**Economic and Social Council**Distr.: General  
20 February 2020

**World Forum for Harmonization of Vehicle Regulations****Working Party on Passive Safety****Sixty-seventh session**

**UN Regulation No. 17 (Strength of seats)****Proposal for the 10 series of amendments to  
UN Regulation No. 17 (Strength of seats)****Submitted by the expert from the European Commission on behalf of  
the Drafting Task Force \***

The text reproduced below was prepared by the expert from the European Commission on behalf of the stakeholders of Drafting Task Force to transpose UN Global Technical Regulation No. 7, Phase 2 (GTR7-PH2) into UN Regulation No. 17. The basis is working document ECE/TRANS/WP.29/GRSP/2019/27; then following the discussion during the December session of GRSP, the web meeting was held in January 2020. Some modifications were made to the noted working document. The modifications to the current text of the UN Regulation are marked in bold or strikethrough characters.

Figure 1  
Non-Use Warning Labels

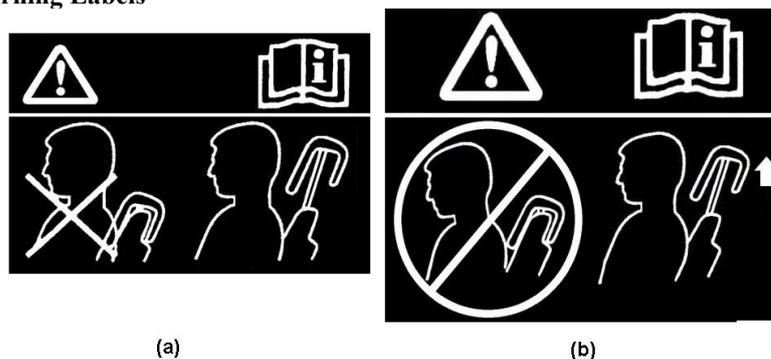
- 5.8.4.5. The presence of a non-use position of a head restraint shall be marked with a label, in the form of a pictogram which may include explanatory text. The label shall either provide an indication when the head restraint is in a non-use position or provide information to enable an occupant to determine whether the head restraint is in a non-use position. The label shall be durably affixed and located such that it is clearly visible by an occupant when entering the vehicle to the designated seating position. Examples of possible designs of pictograms are shown in Figure 1."

Figure 4-1

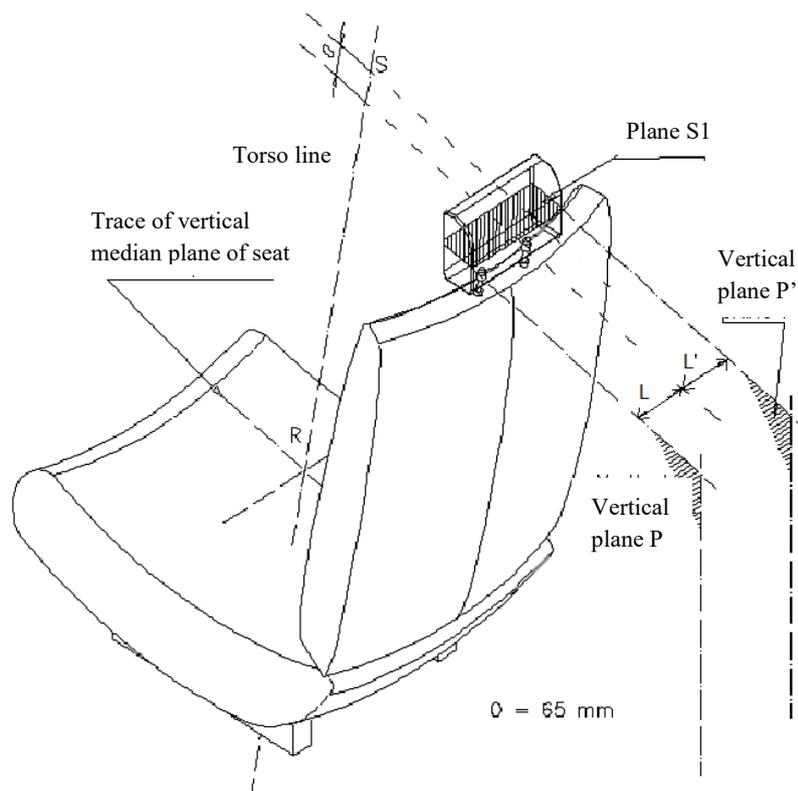
- 2.4. Measure the distances  $L$  and  $L'$  in the plane  $S1$  between the vertical longitudinal planes passing through the torso line and the planes  $P$  and  $P'$ .

Figure 4

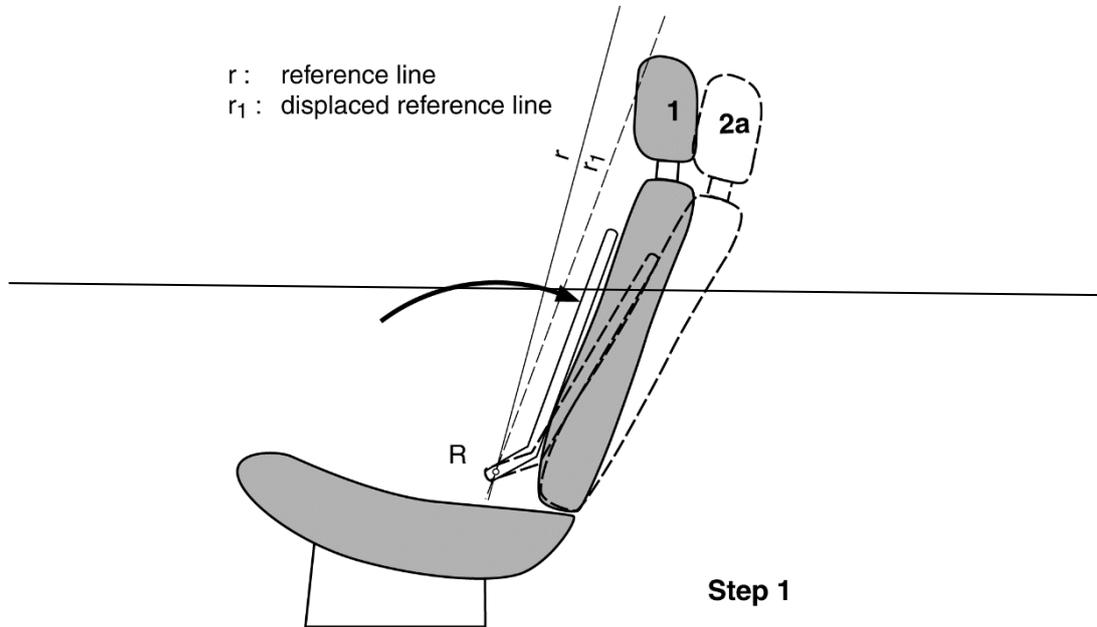
### ~~Details of lines and measurements taken during tests~~

1. ~~Original unloaded position.~~
- 2a. ~~Displaced position by applying to the manikin's back a moment of 373 Nm about the R point, defining the position of the displaced reference line  $r_1$ .~~
- 2b. ~~Displaced position by applying to the 165 mm sphere a force F producing a moment of 373 Nm about the R point, keeping the displaced reference line  $r_1$  in place.~~
3. ~~Position after displacement by the force F increased to 890 N.~~

Figure 8-1  
**Measurement of a Vertical Gap "a". Example of horizontal gaps**

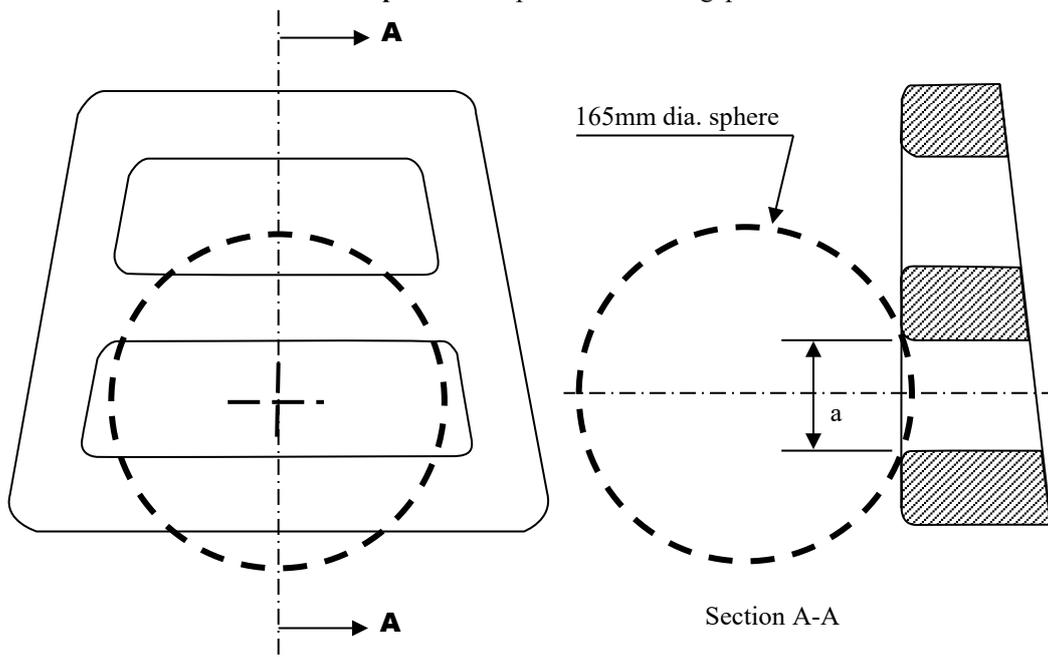
2.5. Determine the gap dimension by measuring the straight line distance between the inner edges of the two furthest contact points, as shown in Figures 8-1, 8-2 and 8.3.

**Figure 8-4**  
**Measurement Gap between Head Restraint and Top of the Seat Back**

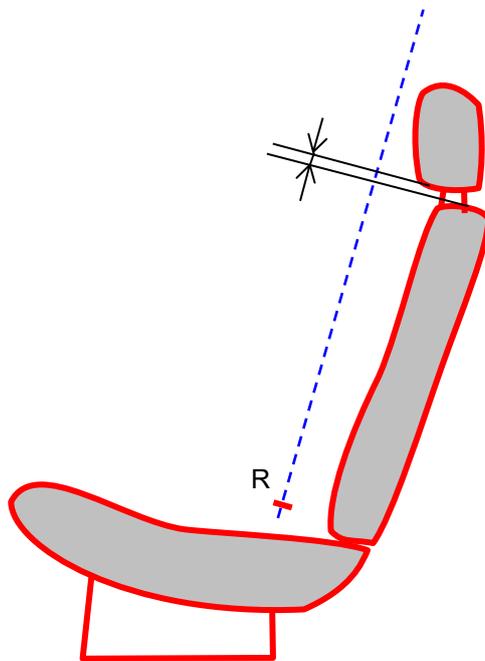
- 5.6.5. **Gaps between the Head Restraint and the Top of the Seat Back**  
When measured in accordance with Annex 8, there shall not be a gap greater than 60 mm between the bottom of the head restraint and the top of the seat back if the head restraint cannot be adjusted in height.  
In the case of head restraints adjustable in height to more than one position intended for occupant use, when measured in accordance with Annex 8, there shall not be a gap greater than 25 mm between the bottom of the head restraint and the top of the seat back, with the head restraint adjusted to its lowest height position.

Figure 10-5

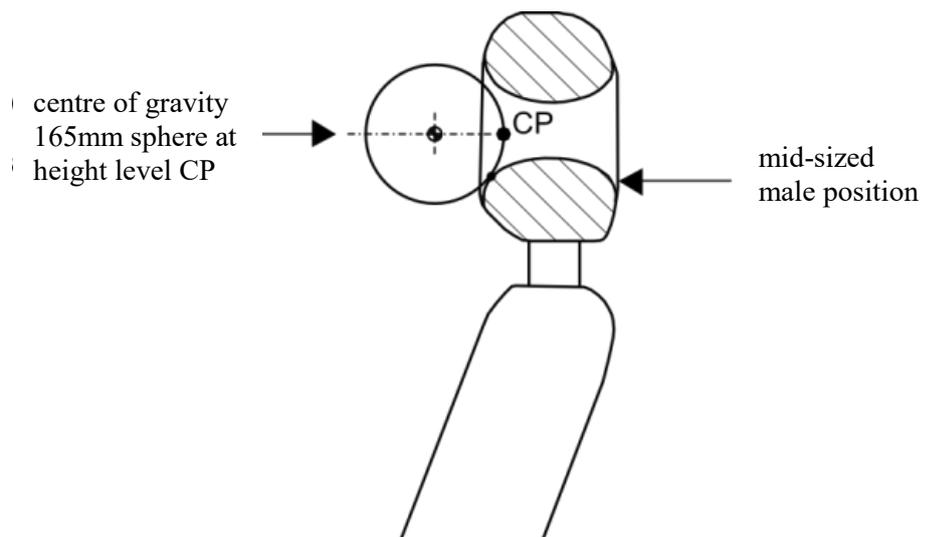
- 5.6.7. **The height of the front contact surface of the head restraints, measured as described in Figure 10-6 of Annex 10 shall not be less than 100mm except for integrated head-restraints.**
